Access Compliance Report

Public Rights-of-Way

Intersection ID: 28625	Main Street: GREYBRIAR_FOREST_LN	Cross Street: PEDLAR_MILLS_RD	Location: NE
ADA ID: 664769A9D051	Ramp Type: BlendTrans1	Initial Pass/Fail: Fail	Overall Compliance: No
		Severity Score: 17.5

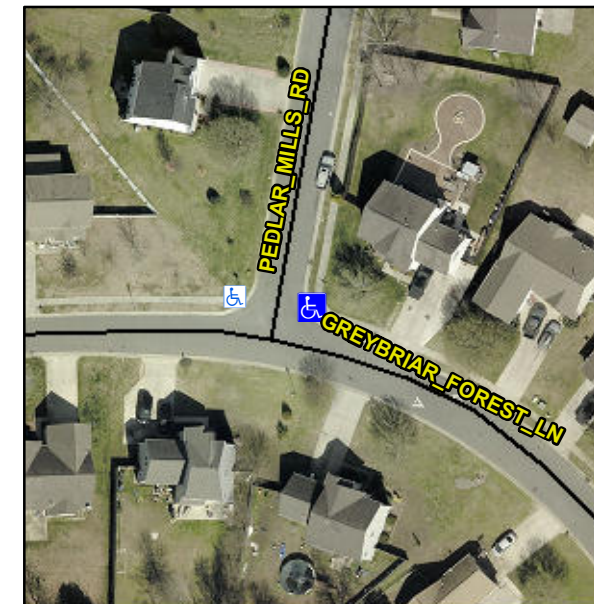
Not Found, R304.5.1

Compliance	Description	Data	Compliance	Description	Data
N/A	Ramp Length (in)	47.3	Yes	BlendTrans Slope (%)	3.3
No	Ramp Width (in)	34.0	Yes	BlendTrans XSlope (%)	1.1
N/A	Flare Type LT	N/A	N/A	Flare Type RT	N/A
N/A	Flare Slope LT (%)	N/A	N/A	Flare Slope RT (%)	N/A
N/A	Flare Traversable LT?	N/A	N/A	Flare Traversable RT?	N/A
N/A	Landing Length (in)	N/A	N/A	DWS Provided?	N/A
N/A	Landing Width (in)	N/A	N/A	DWS Contrast?	N/A
N/A	Landing Slope (%)	N/A	N/A	DWS Length (in)	N/A
N/A	Landing X Slope (%)	N/A	N/A	DWS Full Width?	N/A
N/A	Landing Curb? (Y/N)	N/A	N/A	DWS Offset (in)	N/A
N/A	Shared Landing?	N/A			
N/A	Gutter Ponding?	N/A	N/A	Gutter Slope (%)	N/A
N/A	Gutter Lip Ht (in)	N/A	N/A	Gutter X Slope (%)	N/A
N/A	Painted X Walk1?	No	N/A	Painted X Walk2?	No
	X Walk 1 Direction	To W		X Walk 2 Direction	To S
	X Walk 1 Width (in)	N/A		X Walk 2 Width (in)	N/A
	X Walk 1 Slope (%)	5.9		X Walk 2 Slope (%)	1.8
	X Walk 1 X Slope (%)	0.8		X Walk 2 X Slope (%)	1.3

N/A	Ramp inside XWalk1?	N/A	N/A	Ramp inside XWalk2?	N/A
	Road Slope (%)	1.4		Clear Space?	N/A
	Road X Slope (%)	3.8	N/A	Clear Space to XWalk (in)	N/A
N/A	Any Obstructions?	N/A	N/A	Storm Grate/Utility Hazard?	N/A
	Obstruction Type			Storm Grate/Utility Type	
		N/A			N/A
			Yes	Surface Condition? (G/P)	Good
			No	Curb Slope (%)	53.7

Remove & Replace Curb Ramp With Two New Directional Ramps or Equivalent.
